Item 5.**Development Application: 15-17 William Street, Alexandria - D/2020/1059**

File No.: D/2020/1059

Figure 9: building separation between the eastern and western townhouses has been increased from 8.2m to 9m, stated above

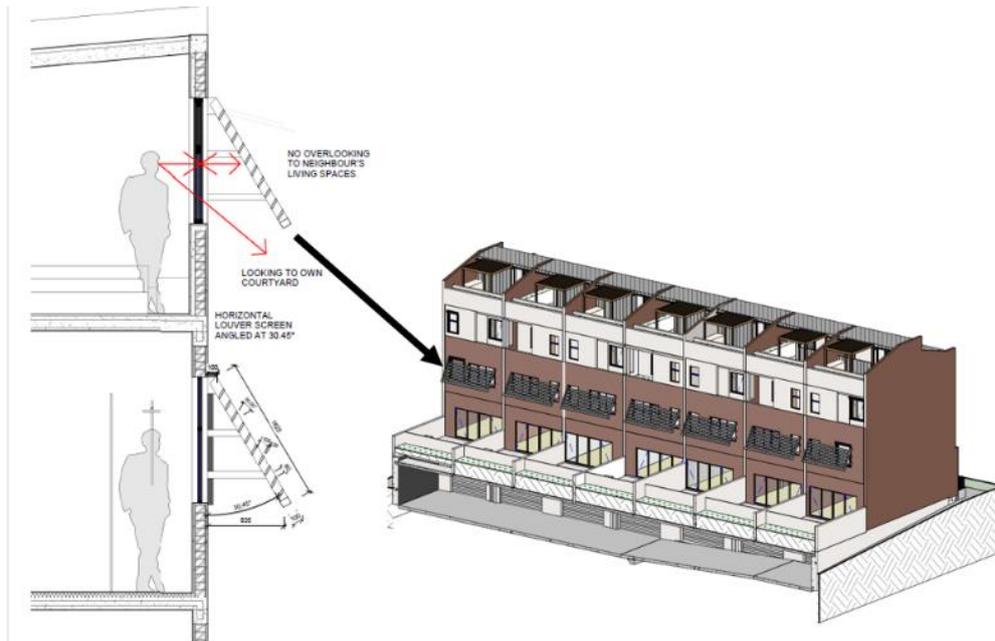
- (c) The separation distance between the eastern and western townhouses has been increased from 8.7m to 9m (see Figure 9) and external privacy screens have been provided for level 1 bedroom windows facing communal courtyards (Figure 10 below). Conditions are recommended in relation to the privacy screens, to ensure they will successfully mitigate visual privacy impacts (see discussion section below).

68. Level 1 bedrooms will directly overlook the courtyards at the centre of the site and are not offset to avoid mutual overlooking between bedrooms. Buildings are separated by 9m (Figure 9 above). The bedroom windows are themselves, directly overlooked from the upper levels and roof terraces of opposing dwellings.

Figure 24: Fourth storey setback from William Lane. Roof terraces set back from William Street

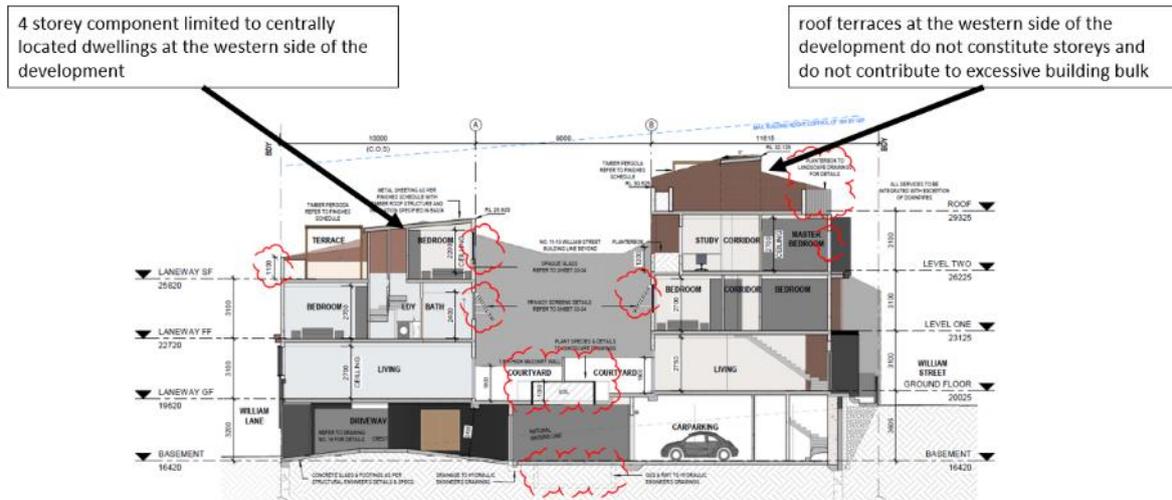
- (a) the 4 storey character results from steep site topography whereby the street frontage to William Lane is a full storey lower than the street frontage to William Street (Figure 24 below). Parking areas under dwellings facing William Lane contribute to an additional storey, however building bulk is set back from the William Lane frontage;

- (b) the development has a 3 storey character as viewed from the public domain of both street frontages and is consistent with the height of adjoining development at the southern boundary (Figure 25 below). Roof terraces for dwellings facing William Street are set back from the building edges and maintain a 3 storey character;

Figure 26: Extract from basement drawing, showing 1.95m of deep soil at the William Street boundary

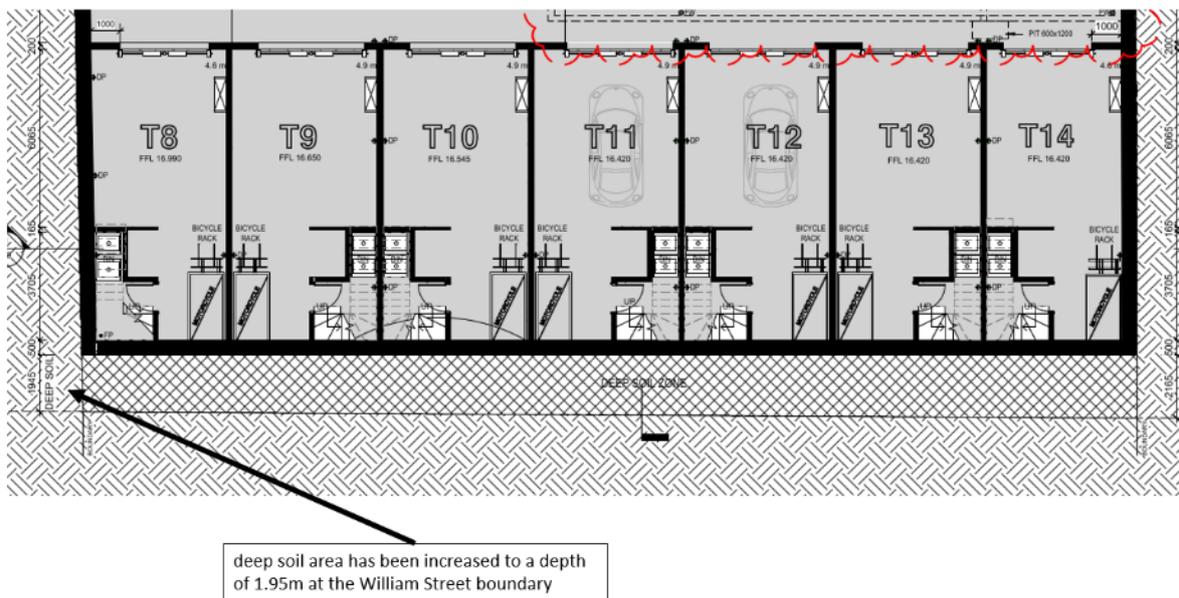
65. Section 4.1.3.4 of SDCP2012 specifies that for lots greater than 150sqm, the minimum amount of deep soil is to be 15% of the site area (165sqm). The proposal has been amended to increase deep soil planting from zero to 6% of the site area (70sqm).

66. While the development does not comply with the minimum provision for deep soil planting, the proposed development is supported on the following basis:

- (a) original drawings lodged with the DA showed a basement that extended to all site boundaries, with no deep soil area provided;
 - (b) the amended proposal provides an area at the William Street frontage that extends for the full width of the site and that has a depth of 1.95m. This is a more generous provision than for neighbouring sites, which provide deep soil areas with a maximum depth of 1.5m to the William Street boundary;

Figure 27: The proposed privacy treatment to bedroom windows facing the internal courtyards

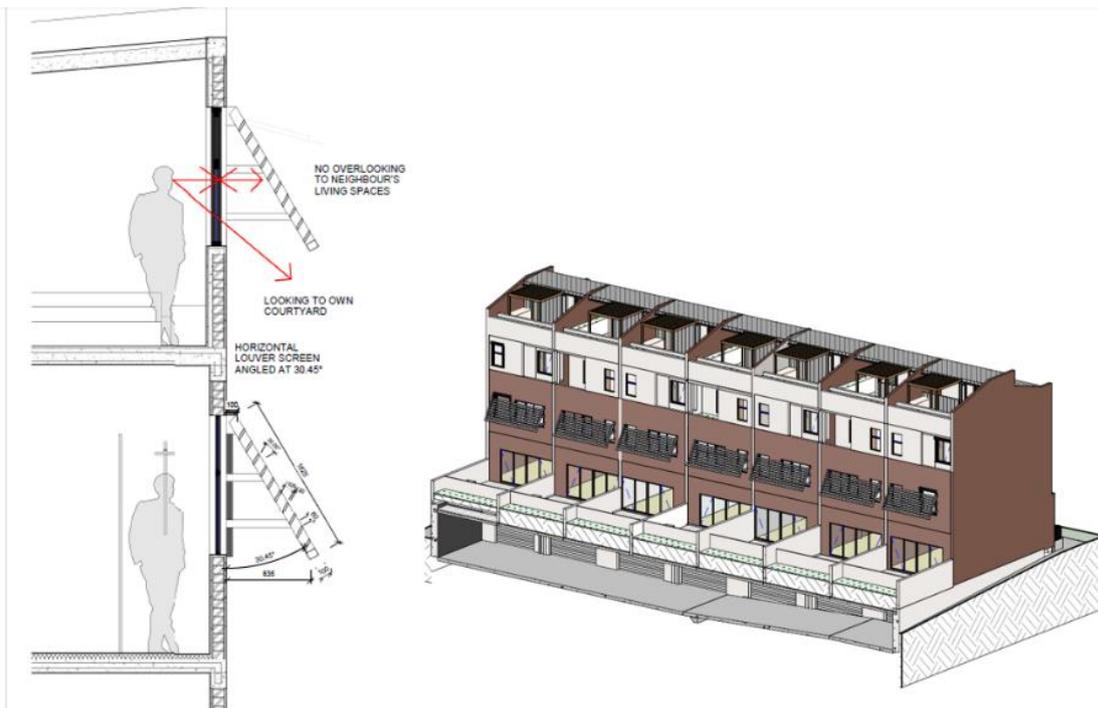
70. This is satisfactory in terms of preventing direct viewing into the bedroom and is also satisfactory in terms of providing light into the windows (Figure 27). However, as shown in Figure 28, the design of the screens results in significant visual privacy impact in that it allows for the direct overlooking downwards into the courtyards of adjoining dwellings.

72. A design modification condition is recommended, requiring the applicant to develop a solution to the issue of direct downwards overlooking over neighbouring courtyards. The condition requires that:

- (a) The design of the level 1 bedroom windows shall be amended to address both the overlooking between dwellings and also the overlooking downwards into adjacent courtyards.

Figure 28: Images provided by the applicant, demonstrating that direct downwards overlooking is acceptable when standing back from windows, and that direct downwards overlooking can be successfully mitigated by a privacy hood at the base of the windows

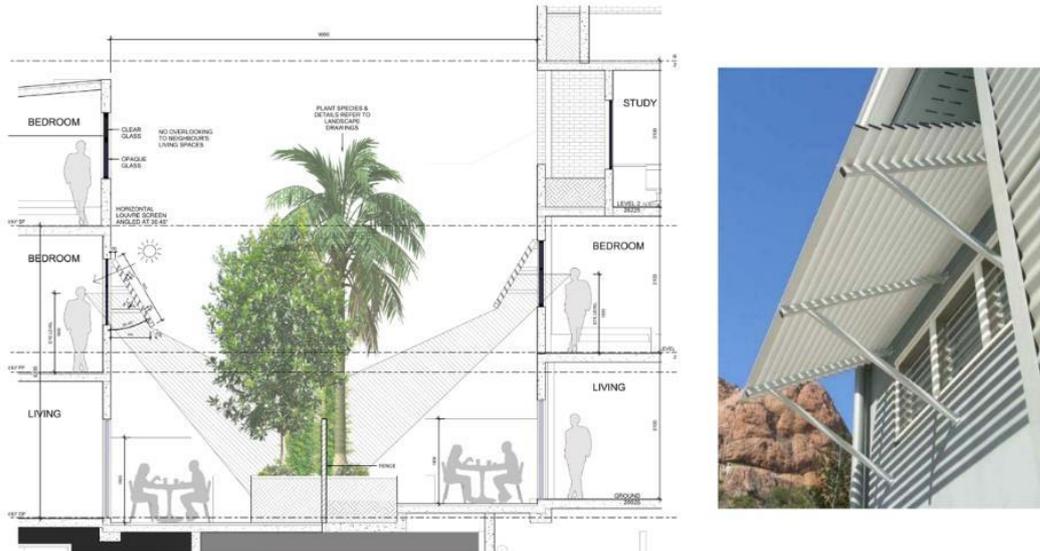
71. Graphics provided by the applicant demonstrate that effective privacy mitigation is only achieved for people within the bedrooms if they are standing 1m away from the inside of the bedroom windows. However, the applicant has demonstrated, by way of Figure 28, that a person standing adjacent to the bedroom window is able to directly overlook the courtyard of the neighbouring, adjoining dwellings (Figure 28 below).

Figure 29: Planter boxes at the roof level are not able to directly overlook neighbouring dwellings and are prevented from overlooking bedrooms by fixed louvre screens

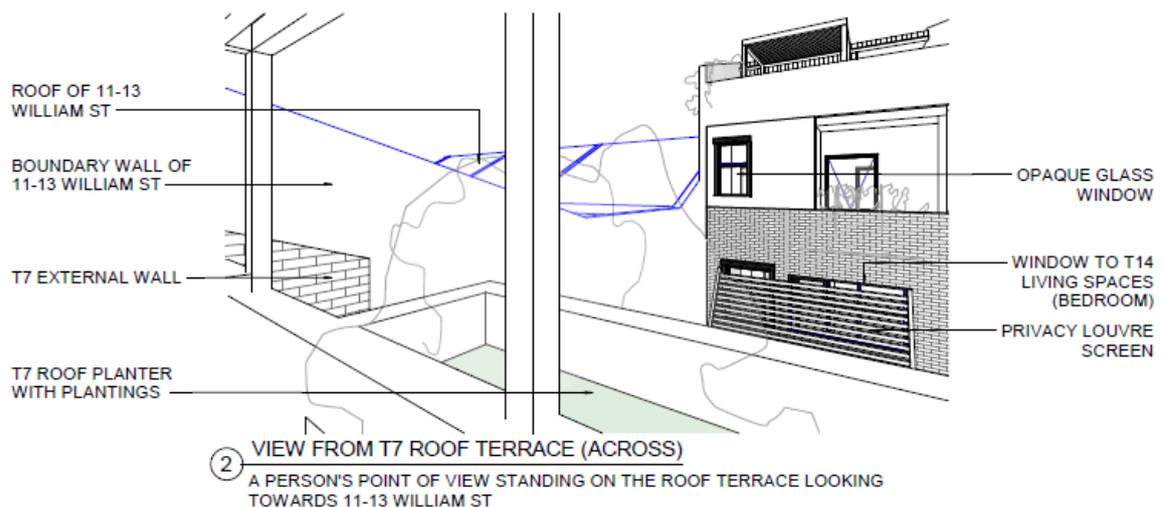
- 73. Drawings have been amended to address visual privacy in relation to direct overlooking from proposed roof terraces.
- 74. Landscaped planter beds are provided at the inner edges of the roof terraces. The planters have a depth of 1.1m and prevent people using the terraces from directly overlooking the living areas of neighbouring dwellings (Figures 29 and 30 below). Proposed louvre privacy screens for bedrooms at the level below prevent the direct overlooking into the bedrooms from the roof terraces.

Figure 31: a condition is recommended to reduce the width of the entry driveway at William Lane

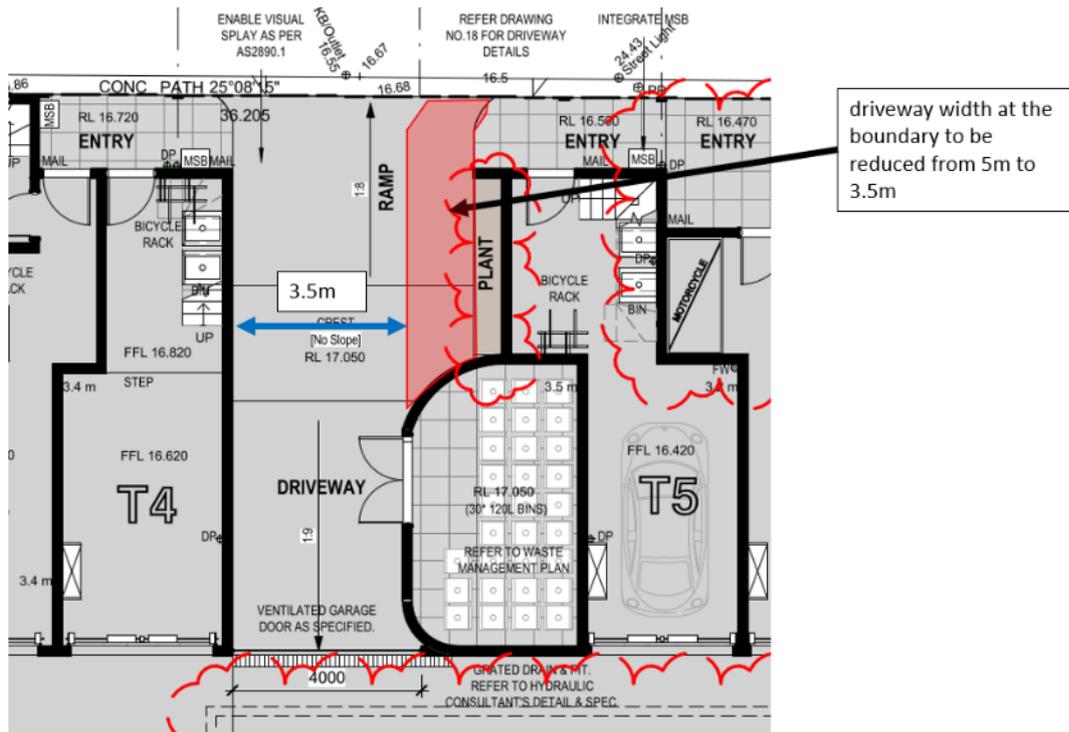
79. The proposal provides a driveway at the entry to the site with a width of 5m, which exceeds the maximum width control of 2.7m. The driveway width narrows within the site to 3.5m and does not provide sufficient width for 2 vehicles to pass one another.
80. The width at the driveway at the boundary is excessive in terms of dominating the entry to the site at William Lane. A condition is recommended that the width of the driveway must be reduced to 3.5m, to provide a consistent driveway width into the parking areas. The northern edge of the driveway (where it is required to be narrowed) shall be constructed as a continuation of the footway adjacent to the entry to dwelling T5.

Figure 33: Level 2 planters are under roofs and are recommended to be deleted

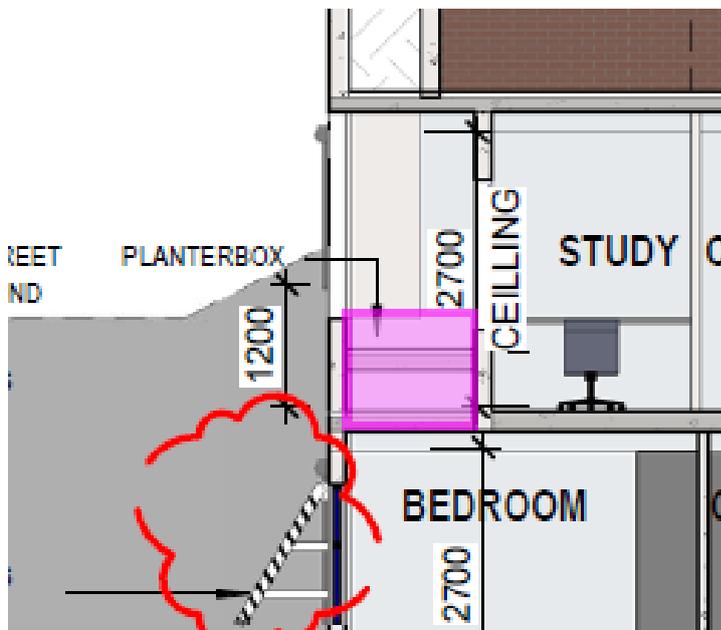
87. Planter boxes are provided at level 2 of the building for dwellings numbered T8-T14 (Figures 32 and 33 below). The design of planters provides for landscaped features that are dangerous and impractical to maintain for the future occupants of the dwellings. Issues with the design of the planters include:

- (a) the planters have a width of 2.3m and a depth of 1.2m. They are accessible only by ladder or from adjacent study and bathroom windows, making them dangerous to maintain for future occupants;

- (b) the planters are covered by roof sections of level 3 above, and will not receive sufficient rainfall and solar access to ensure the success of future landscaped plantings.

88. Council's landscape specialist advises that the difficulties involved in maintaining future landscaped plantings within the Level 2 planters are likely to result in their failure, particularly as they will be maintained by individual tenants (rather than by a garden maintenance specialist engaged by an Owner's Corporation for example). It is therefore recommended that the Level 2 planters for dwellings numbered T8-T14 be deleted, and that the spaces currently containing the planters be redesigned to provide an alternative treatment that is in keeping with the aesthetics and materials of the overall development.
